INFORMATIONAL PCN #: 2761

PCN Title: Add Ejector Pin Mark on TO-252 Packaged Products Manufactured at Diodes Internal Assembly and Test Site (SAT)

PCN-2761-REV1

Example before laser marking		Examples after laser marking on FGs

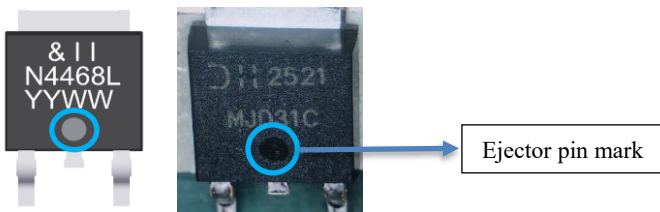
Notification Date:	Implementation Date:	Product Family:	Change Type:	PCN #:
October 15, 2025	Immediately	Discrete and Analog Semiconductors	Product Marking	2761
TITLE				
Add Ejector Pin Mark on TO-252 Packaged Products Manufactured at Diodes Internal Assembly and Test Site (SAT)				
DESCRIPTION OF CHANGE				
This PCN is being issued to notify customers that in order to enhance product manufacturability during the assembly process of finished goods (FGs) as well as to improve product traceability, Diodes Incorporated is in the process of adding an ejector pin mark as shown below to the top surface of TO-252 packaged FGs manufactured at Diodes' internal assembly and test site SAT, located in Shanghai, China. The ejector pin mark indicates the position of each unit within a lead frame strip during the manufacturing process. There will be no change to the actual laser marking of each product.
